15.0.0 Transient and Accident Analyses – Introduction (Related to NUREG-0800, Chapter 15, Section 15.0, “Introduction – Transient and Accident Analyses”)

This chapter of the United States Advanced Pressurized-Water Reactor (US-APWR) Design Certification (DC) Safety Evaluation Report (SER) describes the United States Nuclear Regulatory Commission (NRC) staff evaluation of Mitsubishi Heavy Industries’ (MHI) (the applicant’s) analyses, presented in the US-APWR Design Control Document (DCD), of the plant’s responses to postulated equipment failures or malfunctions. These analyses are used to determine the limiting conditions for operation, limiting safety system settings, and design specifications for safety-related components and systems.

Figure 15.0.3.4.3-1
Calculated pH in Containment Water

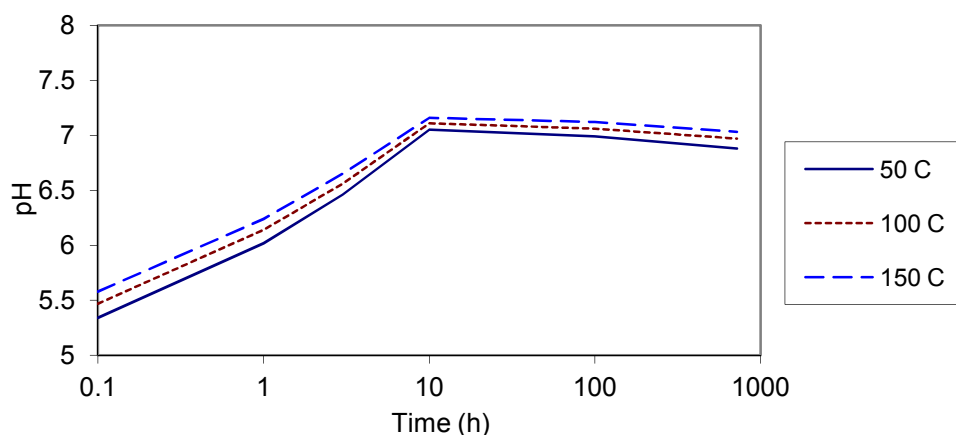
The pH is calculated for three different temperatures (50, 100, and 150 °C), and at times 0.1, 1, 3, 10, 100, and 720 hours. These results are shown in Table 15.0.3.4.3-5 and Figure 15.0.3.4.3-1.

As expected, the pH rises steadily for the first 12 hours, while the NaTB is being added. It declines slightly through the rest of the transient due to the addition of radiolytic acids. At all three temperatures, the pH rises above 7 within the first 10 hours, and remains barely above 7 through most of the accident sequence. A few values do dip slightly below pH=7 near the end of the sequence, although the EPRI model expression produces values slightly higher, as shown in Table 15.0.3.4.3-5. It is not possible to state which of these values is “best”, since their deviation from each other is a good measure of the uncertainty in the calculation itself. However, the calculations indicate that there is very little cushion, as pH is never very far above 7. This is also true of the applicant’s own calculations (response to RAI 460-3484, Question 06.05.02-7), which barely exceed pH=7 as well.
